# Work Order ID 104708

Item Name: Crosstube Turning Detail

DART AEROSPACE LTD	Work Order:	104708
Description: Crosstube Assembly (412 High Aft)	Part Number:	D412-664-243
Inspection Dwg: D412-664-243 Rev: E		Page 1 of 2

DRAWING NO. D412-664-243	TITLE CROSSTUBE ASS'Y (412 HI AFT)	REV. E	DART AEROSPACE LTD ENGINEERING ORDER		D.E.O. NO. D412-664-243-E-2	SHEET NO. SHEET 1 OF 1	SCALE NTS
DRAWN MP	CHECKED AS	MFG. APPR. E	APPROVED MP		DE APPR. H		
DATE 11.09.07	DATE 11.09.19	DATE 11.09.19	DATE 11.09.19		DATE 11.09.19

**D412-664-243  
ASSEMBLY DETAIL**

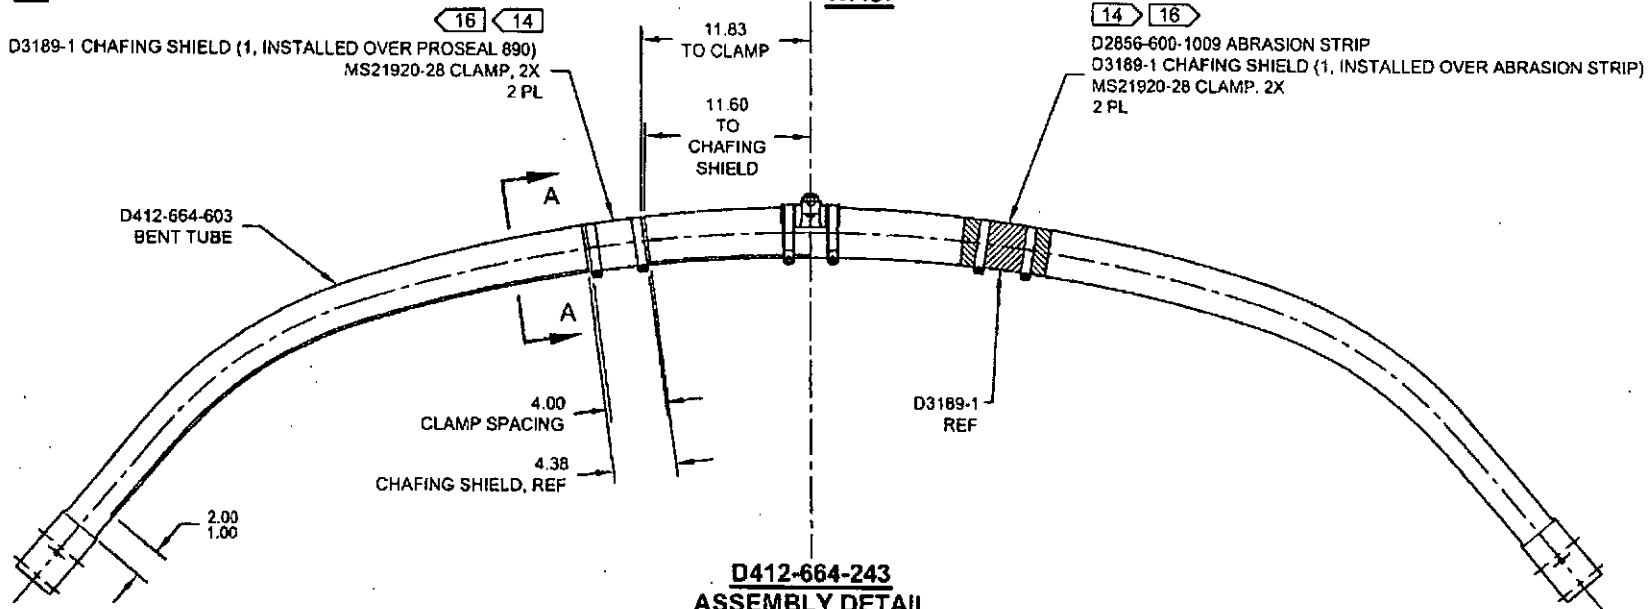
REMOVED ABRASION STRIP IN FAVOR OF A THIN LAYER OF PROSEAL 890. UPDATE INSTALLATION OF CHAFING SHIELDS AND REDUCE TORQUE TO 40-50 IN-LBS. THIS ENGINEERING ORDER SUPERCEDES DEO D412-664-243-E-1.

DRAWING NO. D412-664-243	TITLE CROSSTUBE ASSEMBLY (412 HI AFT)	REV. E	DART AEROSPACE LTD ENGINEERING ORDER	D.E.O. NO. D412-664-243-E-4	SHEET NO. SHEET 2 OF 3	SCALE NTS
DRAWN 97	CHECKED	MFG. APPR.	APPROVED	DE APPR.		
DATE 12.08.21	DATE 12.08.27	DATE 12.08.29	DATE 12.08.29	DATE 12.08.29	DATE 12.08.29

IS:

D3189-1 CHAFING SHIELD (1, INSTALLED OVER PROSEAL 890)  
MS21920-28 CLAMP, 2X  
2 PL

WAS:

D2856-600-1009 ABRASION STRIP  
D3189-1 CHAFING SHIELD (1, INSTALLED OVER ABRASION STRIP)  
MS21920-28 CLAMP, 2X  
2 PL

**SECTION A-A**  
CHAFING SHIELD DETAIL  
VIEW ROTATED, NOT TO SCALE

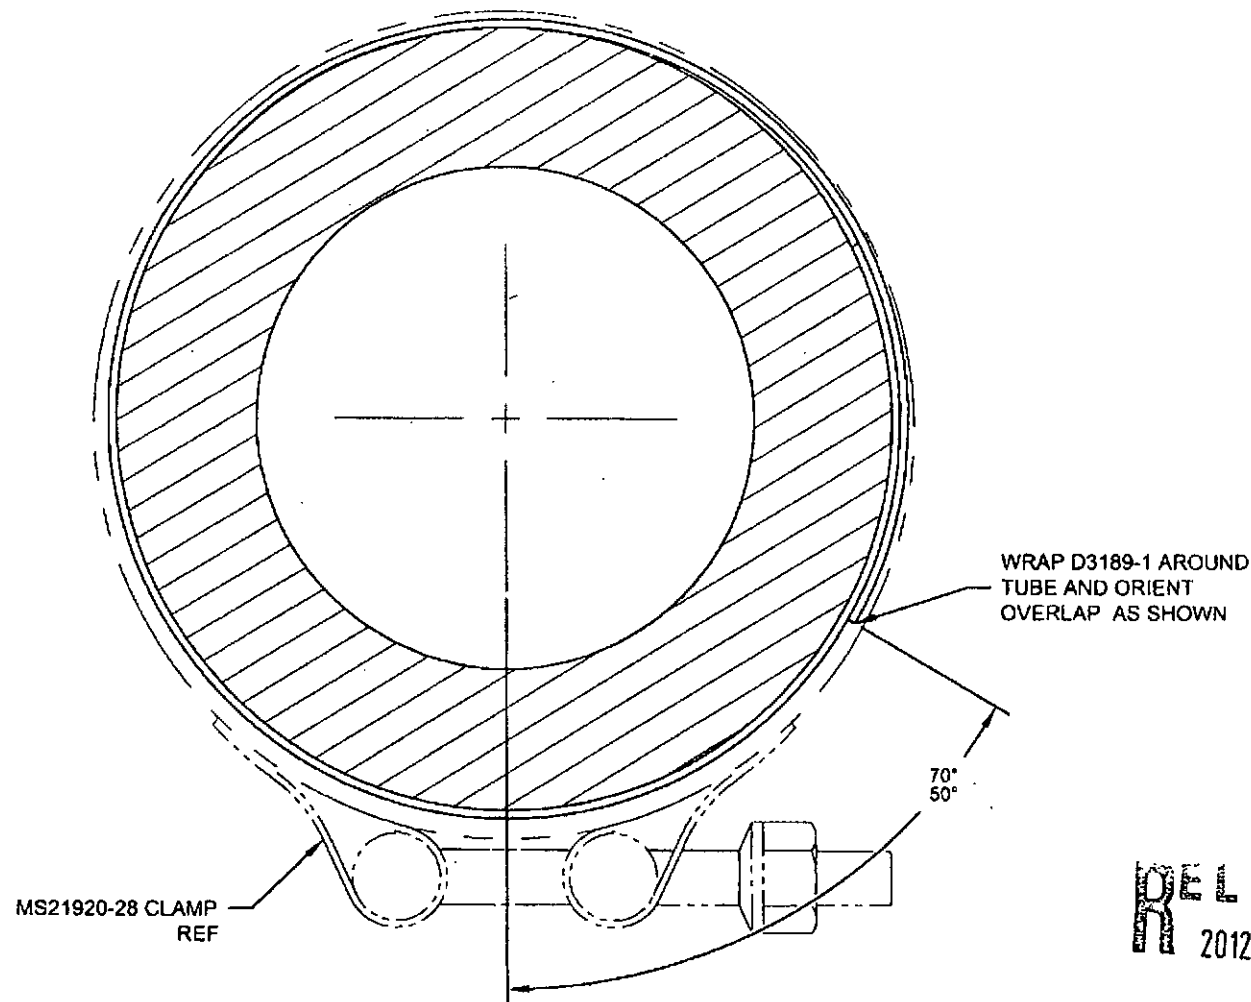
DRAWING NO. D412-664-243	TITLE CROSSTUBE ASSEMBLY (412 HI AFT)	REV. E	DART AEROSPACE LTD ENGINEERING ORDER		D.E.O. NO. D412-664-243-E-4	SHEET NO. SHEET 3 OF 3	SCALE NTS
DRAWN 92	CHECKED	MFG. APPR. MA	APPROVED MD		DE APPR. MD		
DATE 12.08.21	DATE 12.08.27	DATE 12.08.29	DATE 12.08.29		DATE 12.08.29
